OB-8

SCHEMATIC 1679A SHEET 2

ENGINEERING CHANGE ORDER

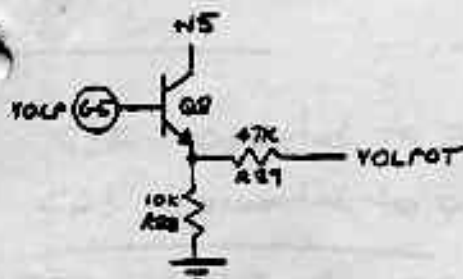
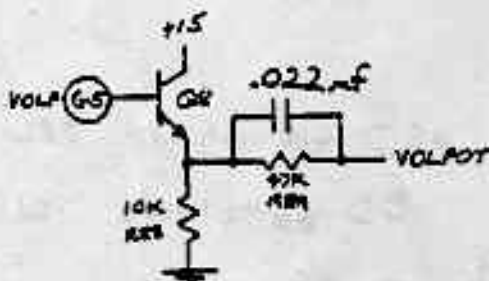
ADD .022mf CAPACITOR IN PARALLEL WITH 47K.

TO ELIMINATE NOISE WHEN CONTROLLING THE VOLUME'S WITH AN EXTERNAL LOW IMPEDANCE VOLTAGE SOURCE.

OB-8 POT. Board 1&2 1681A

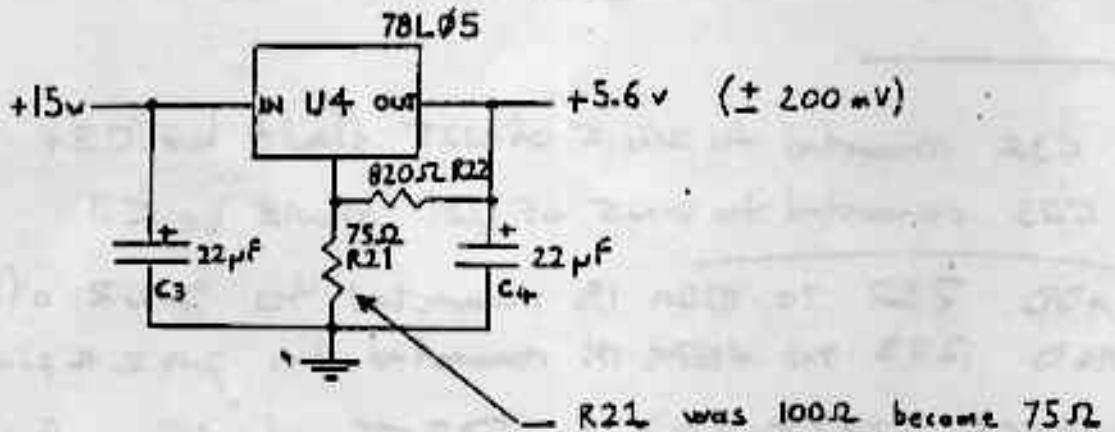
Reduce output of 5.6v Supply.

Increase the active range of the front panel pots

OB-8 VOICE BOARD 1682A

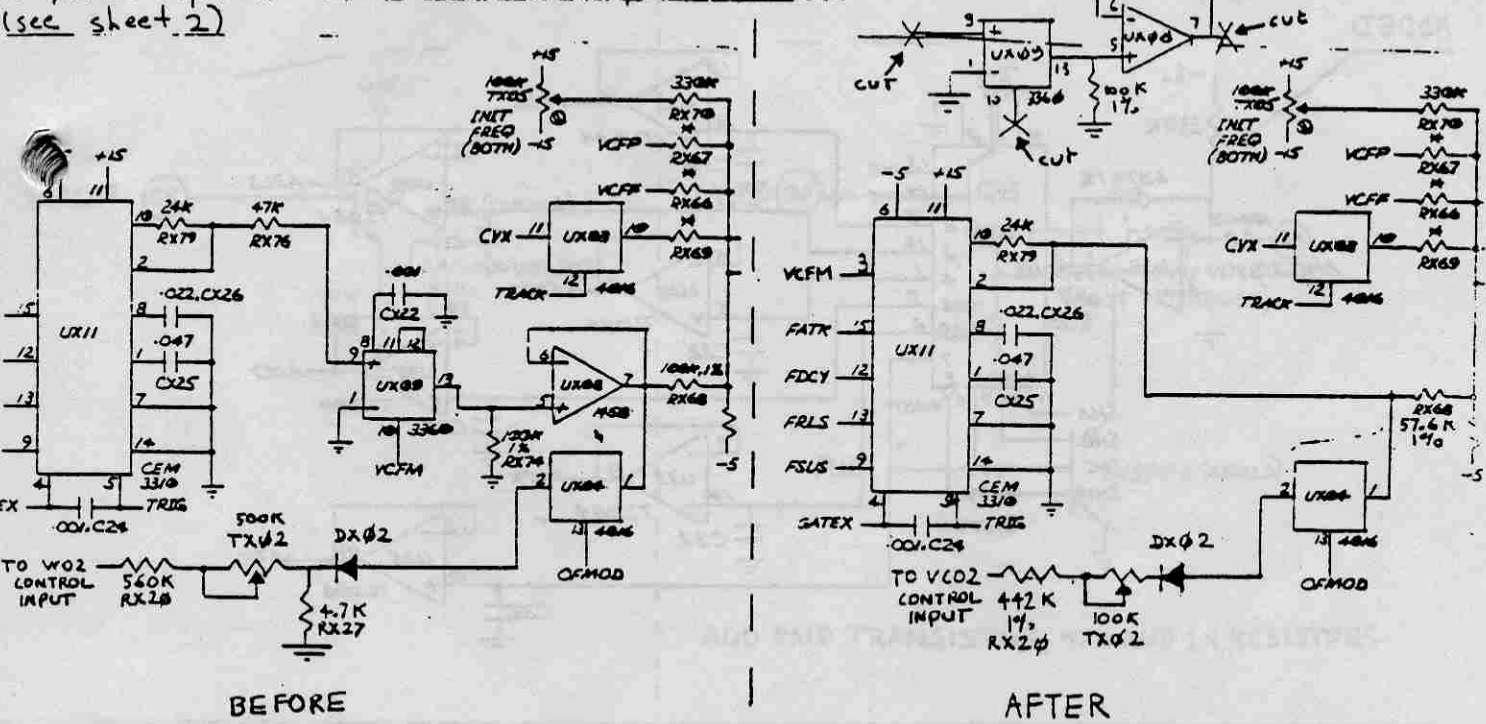
The 336 $\phi$  VCA is bypassed and the 331 $\phi$  in conjunction with the software modulates the amplitude of the envelope. A software revision A-4 or posterior must be installed. R31, at the output of U27 is short circuited. & R30 is removed (see sheet 2)

Improve temperature stability and tracking of VCO2 filter env. modulation

OB-8 VOICE BOARD

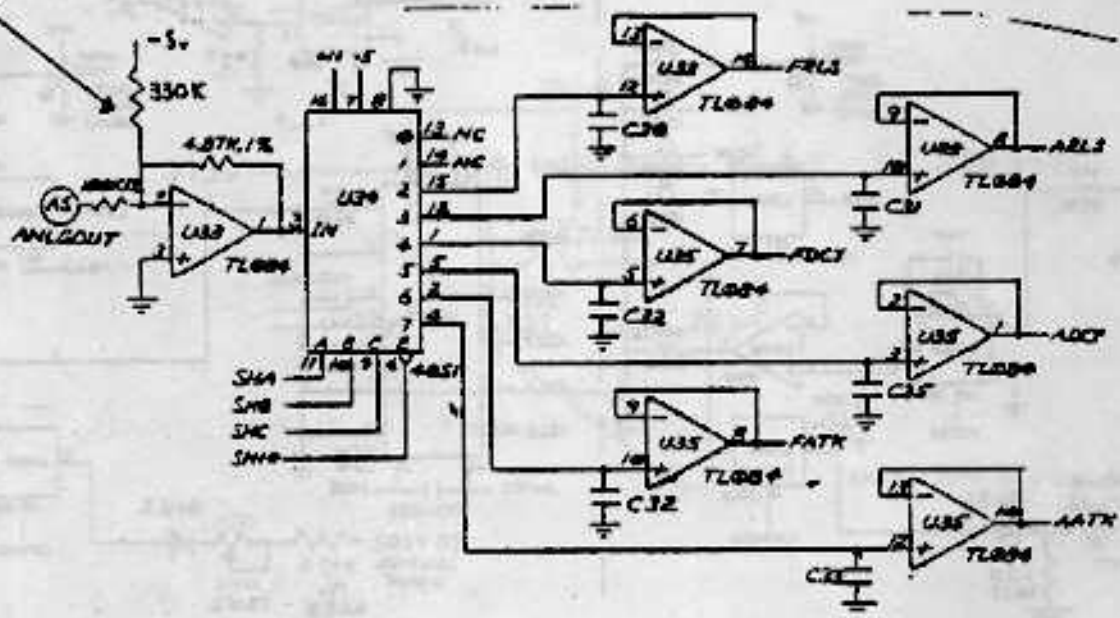
Add a resistor between -5v and pin 2 of U33 (upper & lower voice)

A software revision A-4 or posterior must be installed and the offset calibration of the service center test must be performed.

The offset calibration routine of the service center test can correct the TL084 for positive or negative offset.

SCHEMATIC 1679 A, SHEET 2  
OB-8 PROCESSOR BOARD

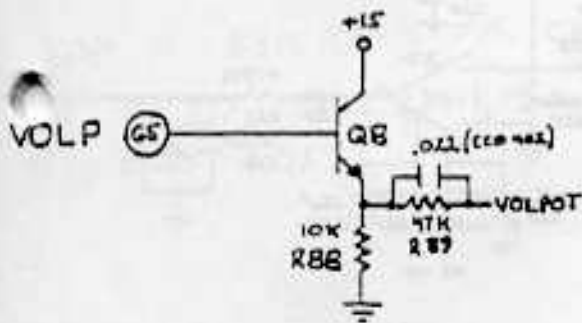
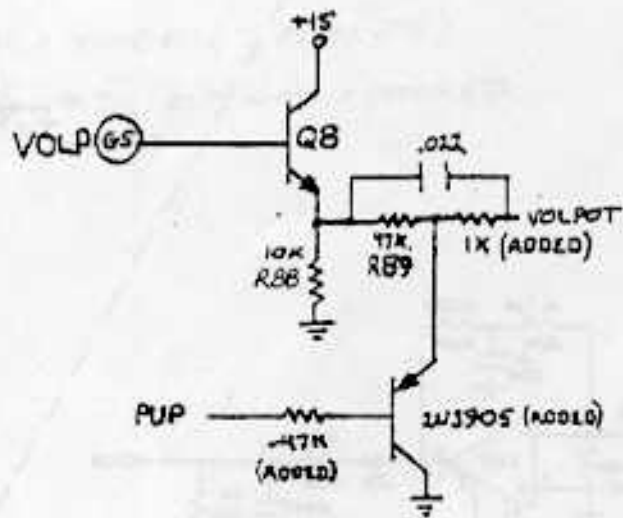
ADD PNP TRANSISTOR, 47K AND 1K RESISTORS

TO REDUCE POWER-DOWN GLITCH AT OUTPUTS

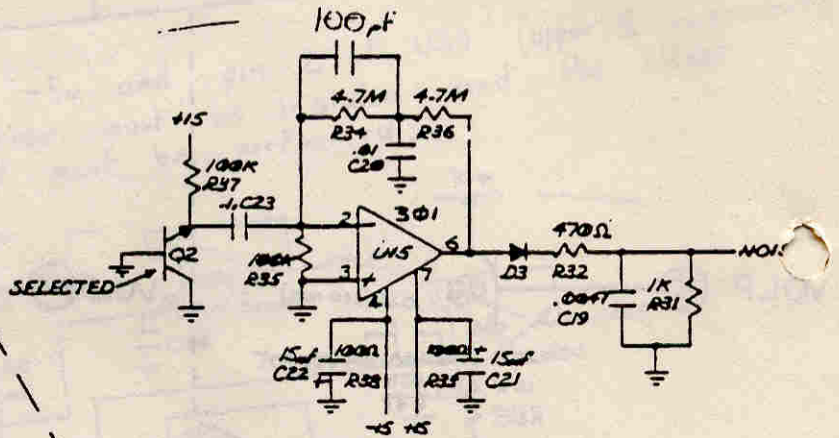
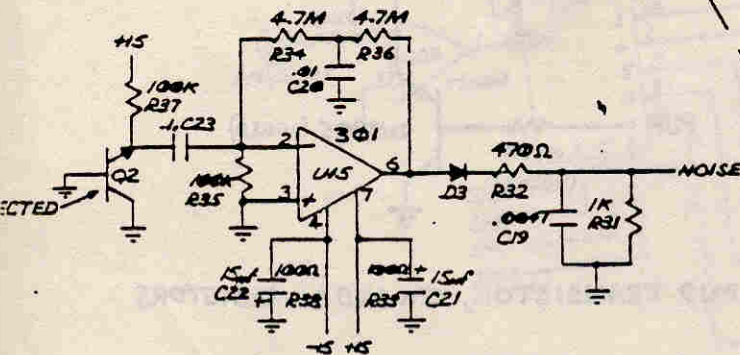
ADD A 100pF CAPACITOR  
IN PARALLEL WITH R34

ON REVISION A PROCESSOR BOARDS, WHEN A SEQUENCER IS CONNECTED,  
DISTORTION BECOMES PRESENT IN THE NOISE GENERATOR.

OB-8 BEND BOX 1680A SHEET 1 OF 1

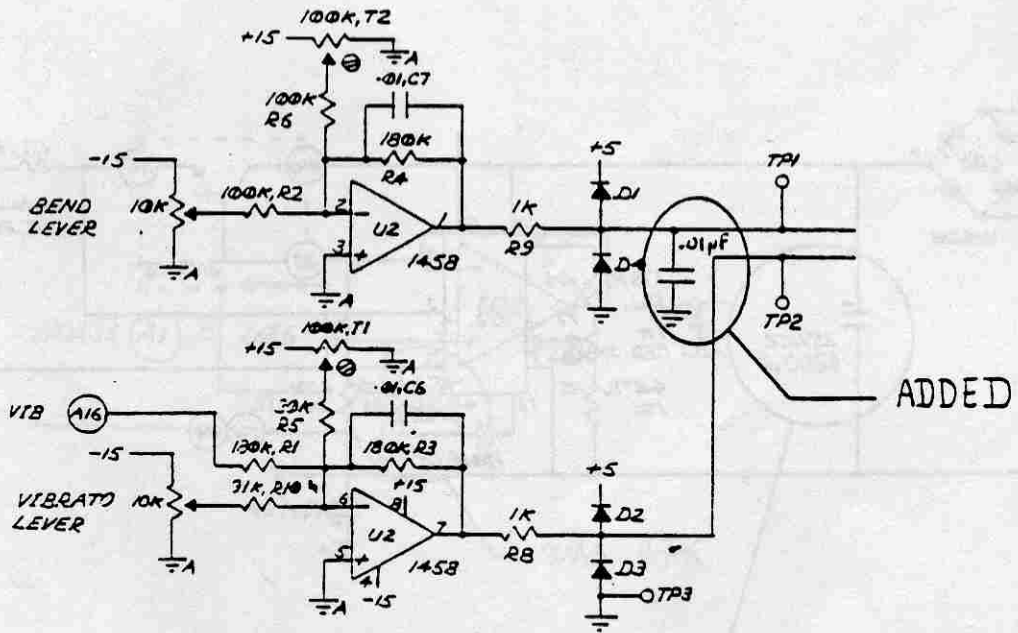
- REMOVES NOISE MODULATION FROM BENDER LEVER

PROCESSOR BOARD- POWER SUPPLY  
1679A SHEET 4 of 4

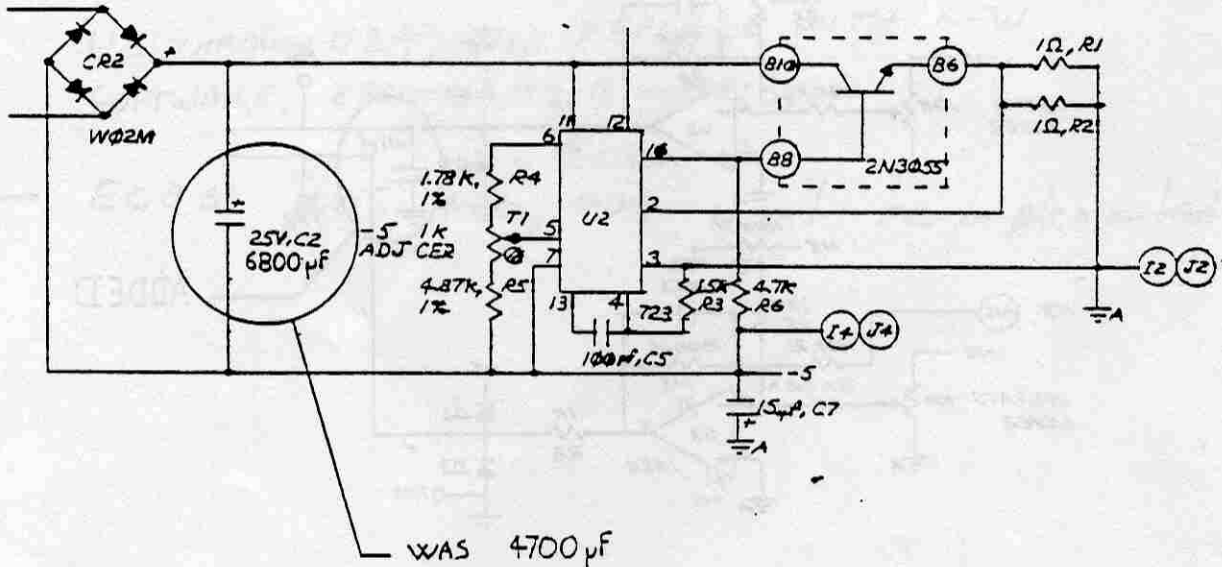
(REFERENCE ECO # 401)

WHEN THE NEW POWER SUPPLY TRANSFORMER (REF. 561021) IS USED, THIS CHANGE DECREASES THE OUTPUT THUMP ON POWER OFF.

VOICE BOARD 1682A SHEET 2 OF 3

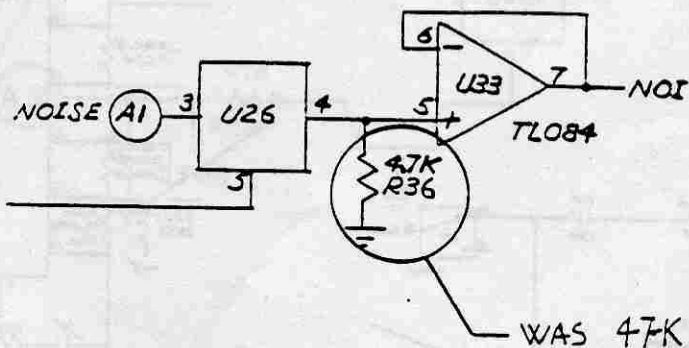
REMOVE LEAK OF NOISE GENERATOR WHEN A VOICE IS GATED

1682A VOICE BOARD

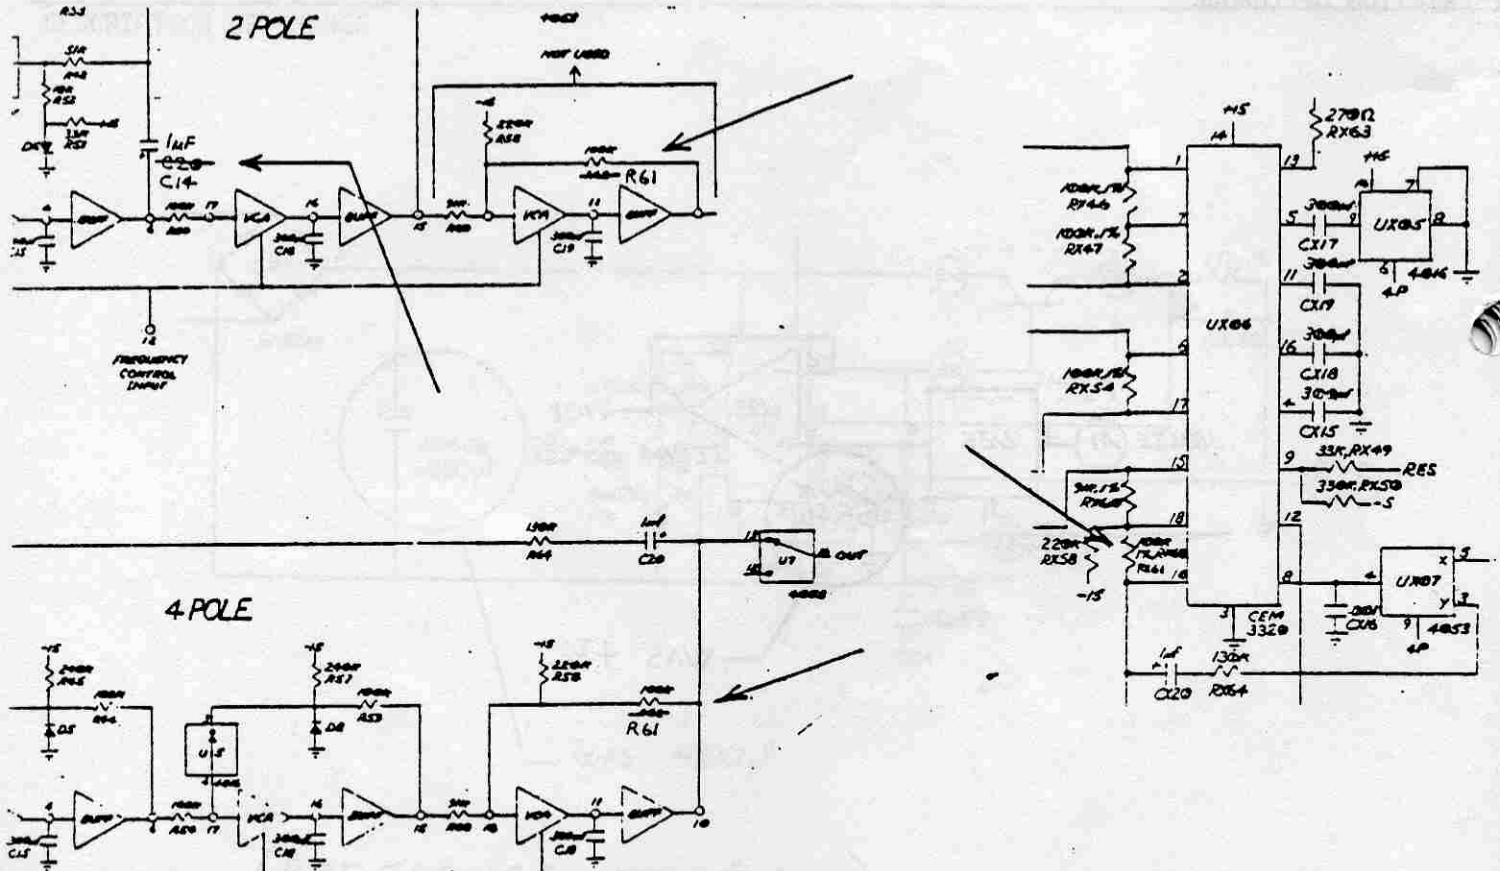
RESISTOR AT UX06 PINS 10, 18 MARKED RX68 SHOULD BE RX61.

CAPACITOR IN 2 POLE/4 POLE CONFIGURATION DRAWING MARKED C20 SHOULD BE C14.

SCHMATIC  
1682 B OB-8 VOICE BOARD (UPPER)

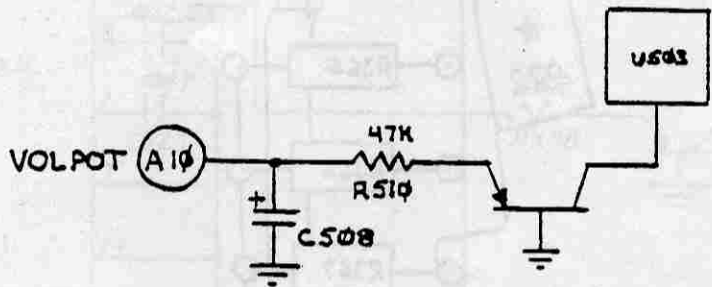
Change C508 from 0.1µf Mylar To 2.2 Electrolytic (Upper Voice only)

To eliminate noise at output at low master volume levels

1632 B OB-8 Voice Board  
1689 B

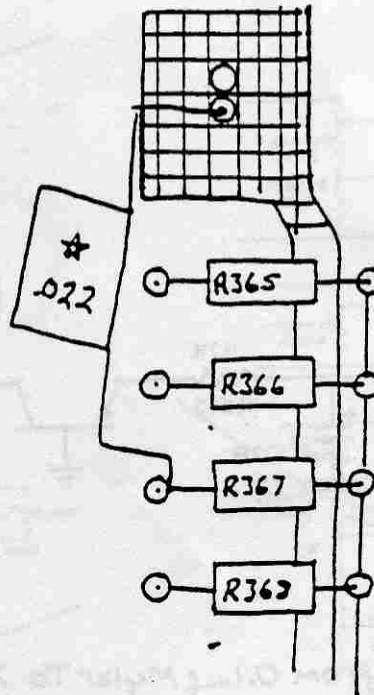
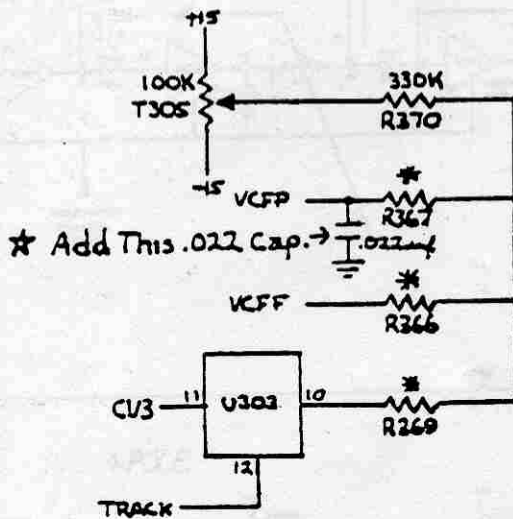
Add a .022 Mylar Capacitor To both The Top and bottom Voice Boards

To Filter-out digital noise picked up along The Filter Pedal line (VCFP) when a Sequencer (05X) is connected.

OB-8 VOICE BOARD 16.82 B SHEET 3 OF 3

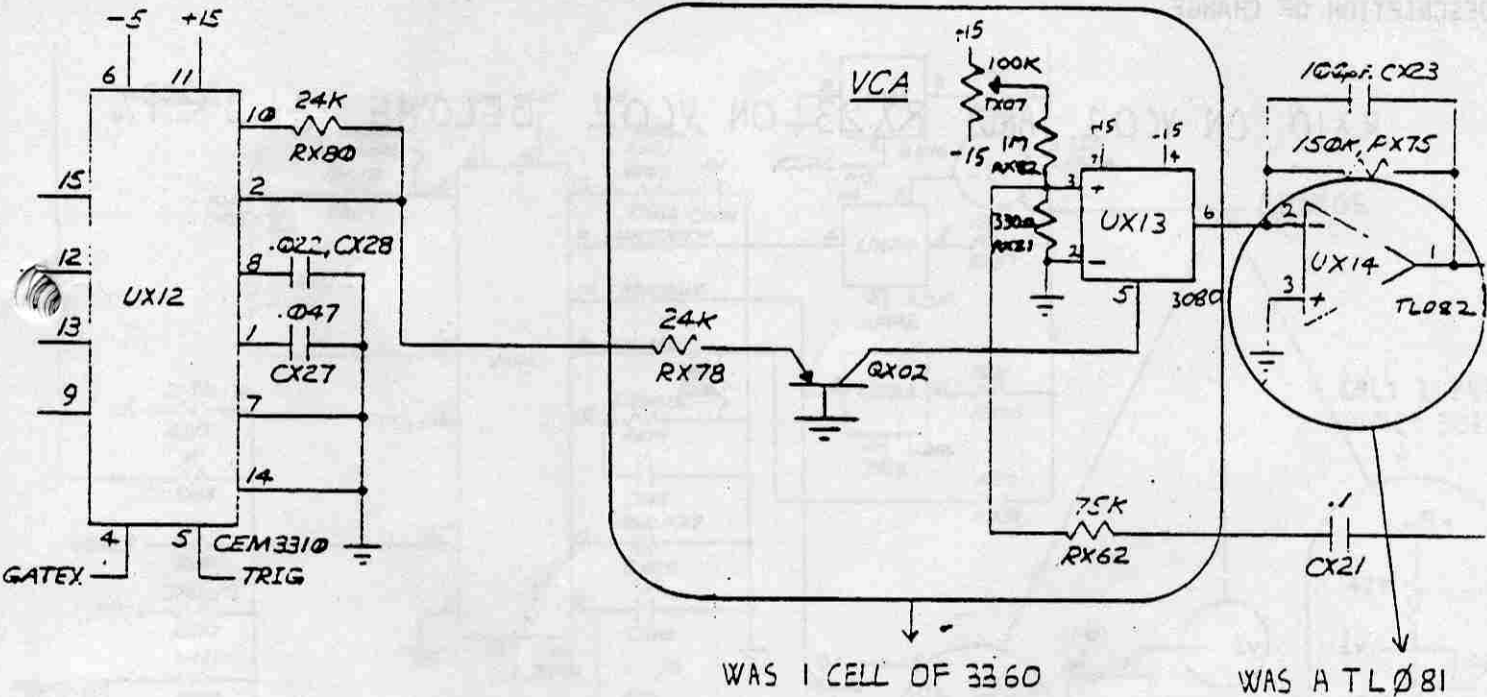
— ALSO: UX08 IS DELETED AND REPLACED BY THE OTHER CELL OF THE TL082 UX14

— RATIONALIZE THE CIRCUITRY

OB-8 VOICE BOARD 1682A SHEET 3 OF 3

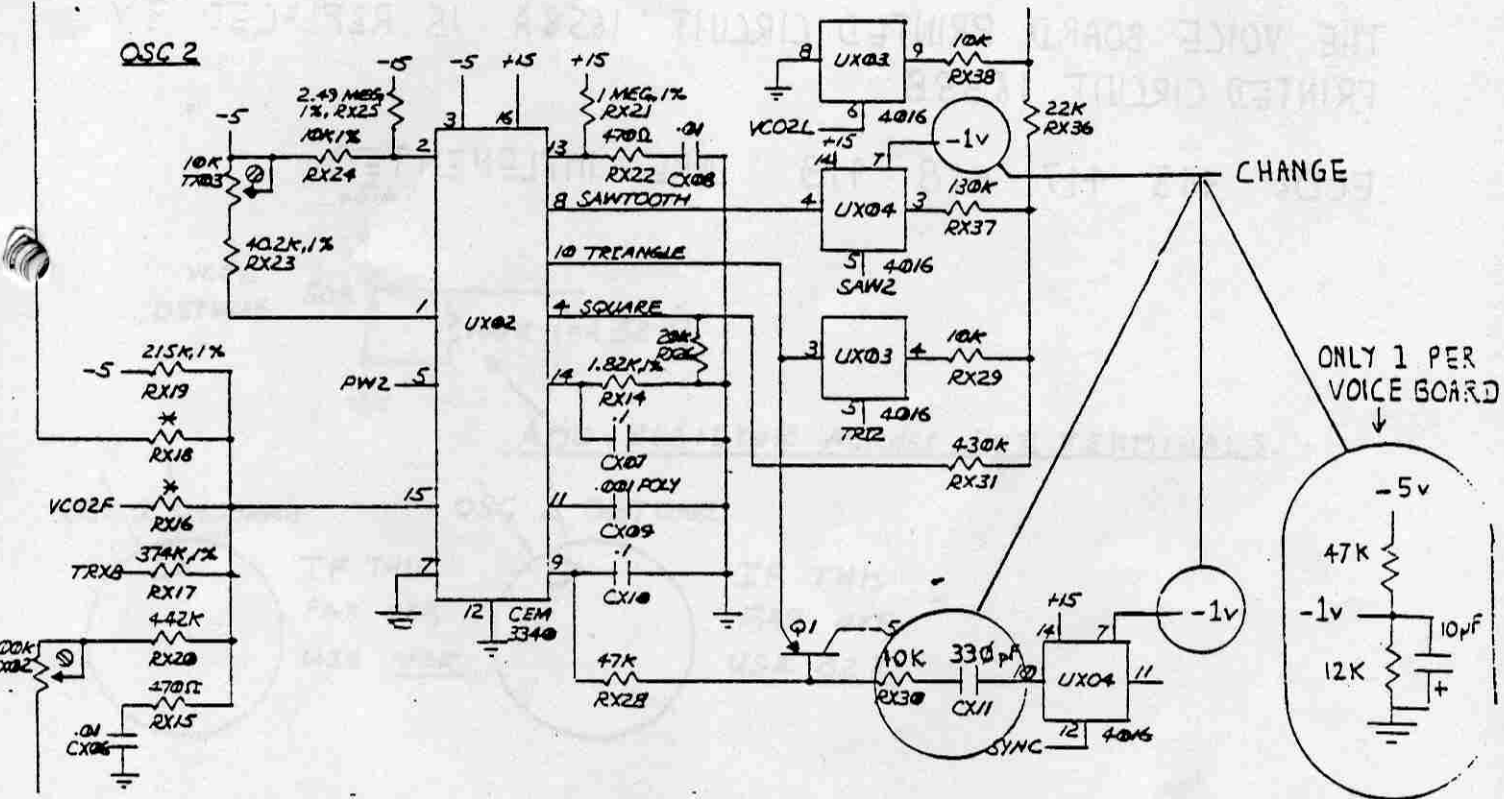
- IMPROVES SYNCHRO SOUND

POT BOARD 1681 B

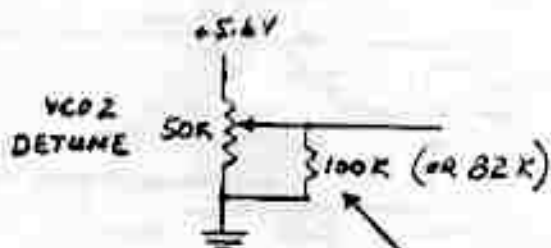
ADD RESISTOR ACROSS POT. TERMINALS.

IF THIS  
FAR OFF,  
USE 100K

IF THIS  
FAR OFF,  
USE 82K

TO CENTER OSC 2 DETUNE CONTROL WHEN LED GOES OFF  
WITH KNOR SIGNIFICANTLY COUNTERCLOCKWISE OF CENTER.

OB-8 VOICE BOARD 1682B SHEET 2

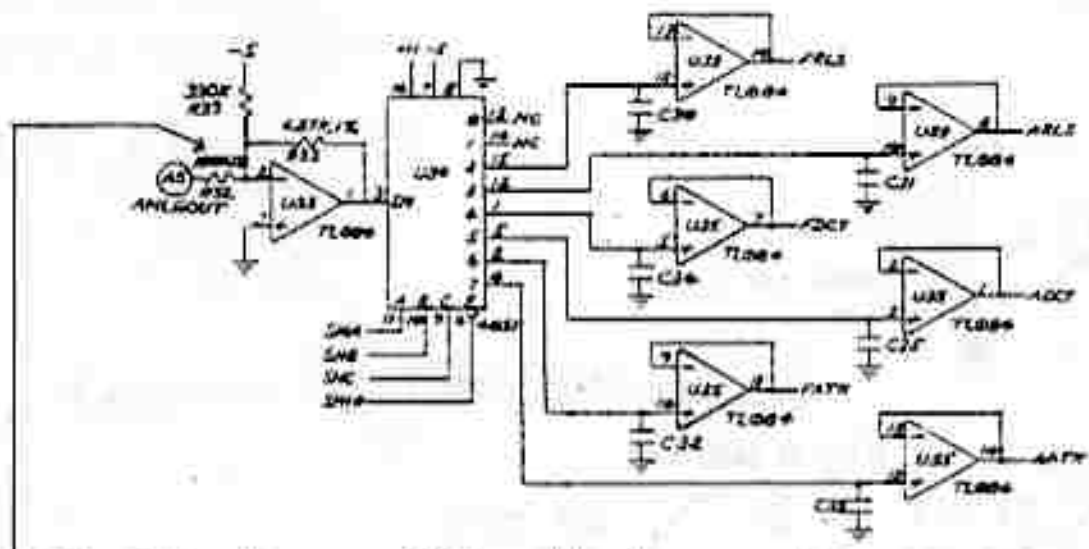
R32 100K 1% are 50Ω matched between Lower and upper Tray.

R32 on the Lower and upper tray are mounted after the two boards are screwed together.

— IMPROVES MATCHING OF TIMING BETWEEN ENVELOPES OF UPPER, AND LOWER TRAY.
